Product Change Notice (PCN)

PCN Number: **PCN-0451113R-01**

Product(s) Affected: **PJ-018H**

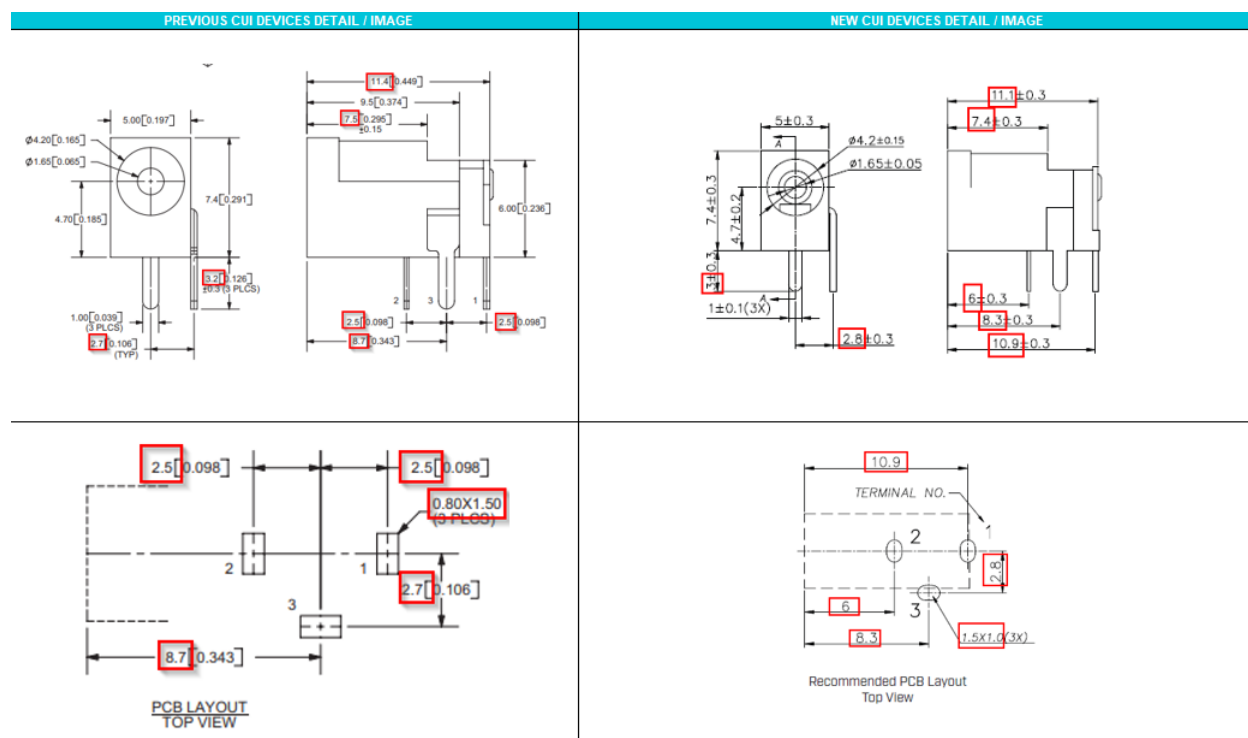
Description of Change: **Minor Housing and footprint differences. Material Change on the housing and terminals. See image Below**

PREVIOUS CUI DEVICES DETAIL / IMAGE

Jack Insertion Depth: 6.6 mm

MATERIAL	PLATING
center pin	copper	nickel
terminal 1	brass	silver
terminal 2	copper alloy	silver
terminal 3	brass	silver
plastic	PBT

parameter	conditions/description	min	typ	max	units
rated input voltage			10		Vdc
rated input current				3.5	A

NEW CUI DEVICES DETAIL / IMAGE

Jack Insertion Depth: 6.1 mm

DESCRIPTION	MATERIAL	PLATING/COLOR
center pin	brass	CuSnNi
terminal 1	brass t=0.4	silver
terminal 2	phosphor bronze t=0.25	silver
terminal 3	brass t=0.4	silver
housing	PA10T (UL94V-0)	black

parameter	conditions/description	min	typ	max	units
rated input voltage			24		Vdc
rated input current				3.5	A
